**BELCONNEN  
 SECTION 32 (PART)**

**From:** Ruis, Melinda  
**Sent:** Friday, 15 February 2008 10:12 AM  
**To:** Walker, Graeme  
**Subject:** Table of response - Block 20 Section 32 Belconnen

**BELCONNEN SECTION 32 BLOCK 20**  
**Draft Lease and Development Conditions**  
**Planning Control Plan**  
**Prescribed Conditions**  
**Site Investigation Report**

Extract from ActewAGL Electricity Services Plan – Note square structure in block, old structure with power supply – ActewAGL currently confirming.

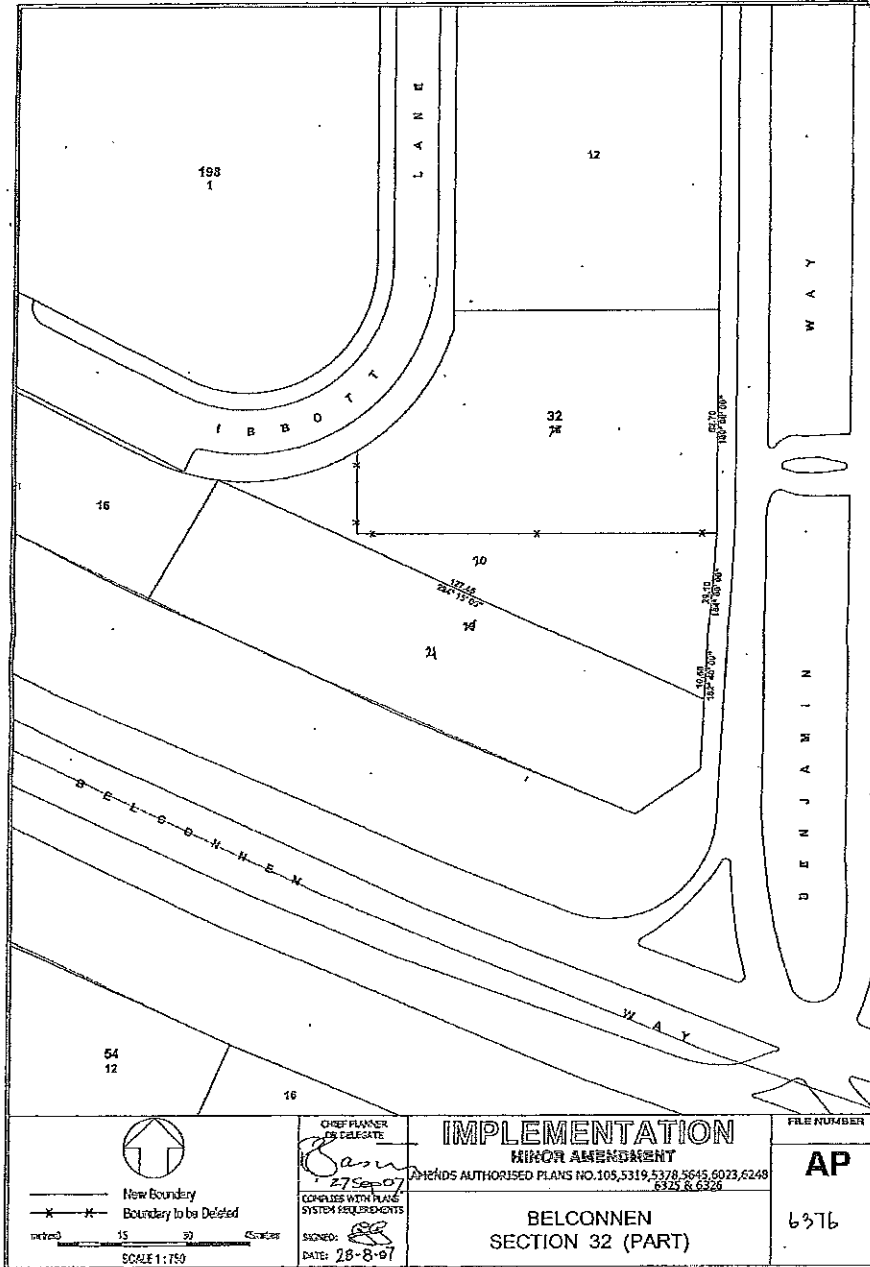
I have gotten hold of ActewAGL regarding the mystery box on Block 20 Section 32 Belconnen. They have advised that there used to be a shed there with a power supply. The shed has been removed, the cables are still there but have been disconnected. So this confirms our discussion last week.
